## Re: Missing and sub-standard pedestrian connections in the Central & Western District

Encl. List of 15 missing links responses

4. Location: Wyndham Street and Centrium Stairway

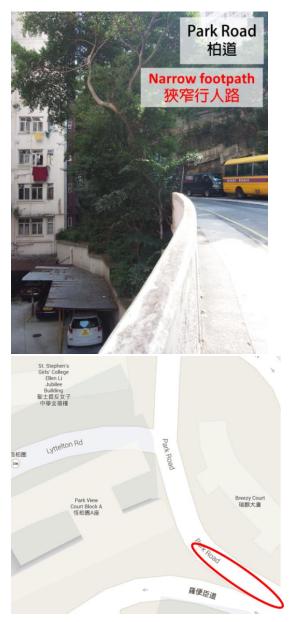
Thank you for acknowledging that there is no site constraint limiting the sightline. Although the concerned location is a one-way street, there is high traffic flow making it difficult for pedestrians to cross the road safely. The signal controlled crossing at the junction of Wyndham Street/ Glenealy/ Lower Albert Road is inconvenient to pedestrians who want to access to Centrium Stairway directly. We suggest adding a zebra crossing with Belisha beacon at the indicated location (red) in the photo below to connect Yau Shun Building with the Centrium Stairway. Relocation of the nearby bus stop may be needed.

6. Location: Breezy Path Problem: Narrow footpath

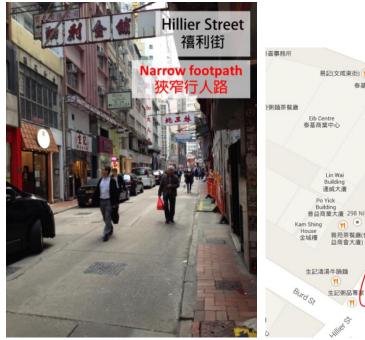
The footpath is missing on the west and very narrow on the east that causes danger to pedestrians. As stated by the Education Bureau [LC Paper No. CB(2)1756/11-12(01)], the site at 2 Breezy Path will be demolished and become the extension of Ying Wa Girls' School under their redevelopment project. Is it feasible to set back the building and realign the road, so as to widen the footpath on both sides? Alternatively, is it feasible to remove the staircase on the west and realign the road to widen the footpath on the east? Since the concerned location is on slope, reducing traffic speed is also needed to ensure the safety of pedestrians.
